ORDINARY COUNCIL MEETING	4
29 APRIL 2014

# REQUEST TO CHANGE DEVELOPMENT APPROVAL AND REQUEST TO EXTEND THE RELEVANT PERIOD - OCEAN BREEZE ESTATE - STAGE 3 - 905L COOYA BEACH ROAD BONNIE DOON

- A. That Council approves the Request to Change a Development Approval over land described as Lot 905 on SP253578 located at Bonnie Doon Road, Cooya Beach to facilitate the sub-staging of Stage 3 of Ocean Breeze Estate as detailed on Drawing No. 1187 C01 Revision E dated 17 January 2014 prepared by Jim Papas Drafting Pty Ltd, subject to the following:
  - 1. Condition 1a be amended to read as follows:-

**APPENDIX 2: AMENDED STAGING PLAN**

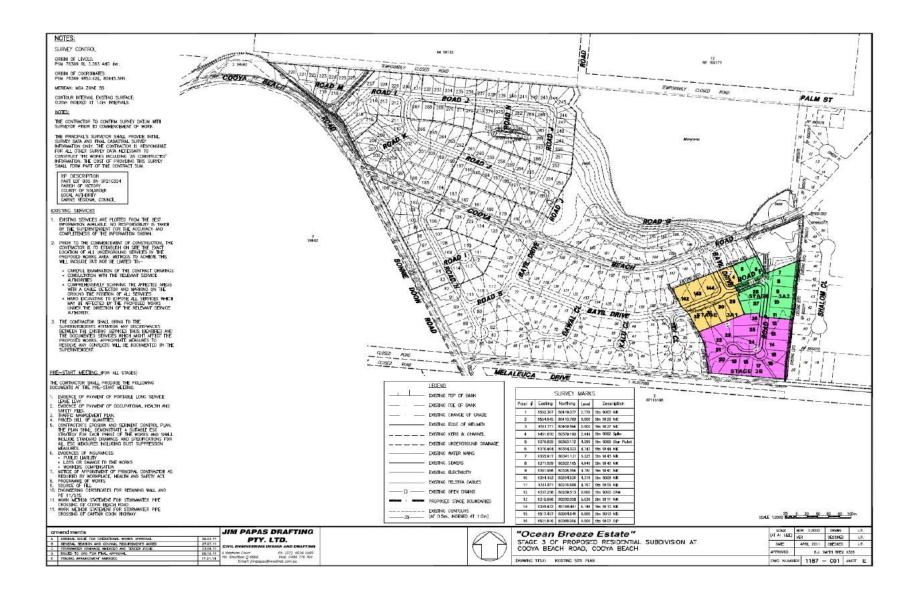
The request to change seeks to amend the staging of the development to enable Stage 3 to be developed in three sub-stages, while the request to extend the approval seeks

The request to change the development approval seeks to amend the staging and provide for three sub-stages within Stage 3 while the request to extend seeks a further two year extension to the operational works approval.

The applicant is seeking approval to allow 3A1 to proceed and to defer the drainage infrastructure works to form part of 3A2 and 3B in a staged format.

## APPENDIX3: APPROXIMATE EXTERNAL CATCHMENT AREA

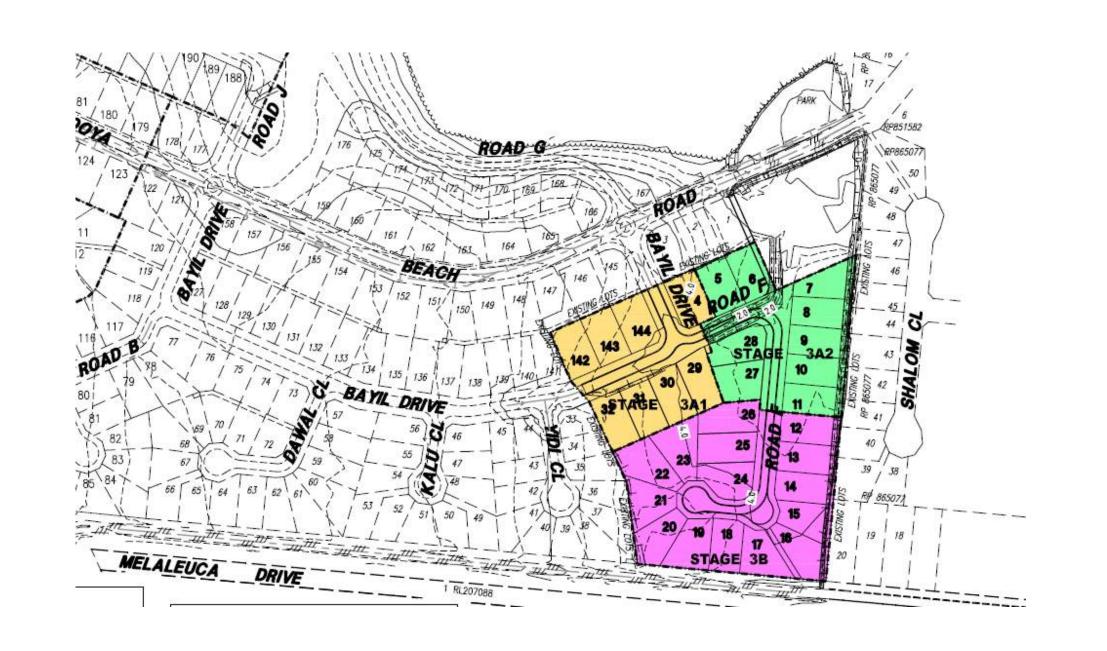
2. There are variances with respect to the size of the external contributing catchment from when the application was first lodged with Council in May 2011 which indicated an external catchment of 0.8 hectares with run off coefficients for the Q5 and Q100 being 0.66 and 0.84 respectively. This has now been adjusted by the applicant to be approximately 8.24 hectares with the run off co-efficient of 0.33 and 0.42 for the respective events. Council Officers estimate the external catchment to be in the vicinity of 10 – 12 hectares using Council GIS and contour data.

With respect to the runoff coefficient, the lower the co-efficient, the assumption is the more permeable the soil. When asked what information was relied upon to qualify these assumptions in the most recent plans submitted, the applicant made reference to bore logs which made reference to sandy loams and sandy clays and not just pure sand. However, Table 4.9.2 of the Queensland Urban Drainage Manual (QUDM) discusses sand versus sandy loam, sandy clay etc. It is the role of the RPEQ to determine what the appropriate values are based on experience and engineering judgement. Where there is possible uncertainty, it is the RPEQ who has to satisfy themselves that all appropriate investigations have been undertaken.

3. Current observations, local knowledge and recent events (prior to Cyclone ITA) would indicate that the catchment does not enjoy high permeable soils given the presence of casual water present on the site and surface water present in the adjacent cane paddock. Council also has water table readings in the immediate vicinity whereby the water table peaks within 200mm from the natural ground level.

The hydraulic model must investigate the scenarios of the initial and continuing infiltration losses set to zero or a runoff coefficient set at 0.7 for

the 5 year event and coefficient of 0.88 for the 100 year event for an external catchment are of 10Ha to determine the peak minor and major events.
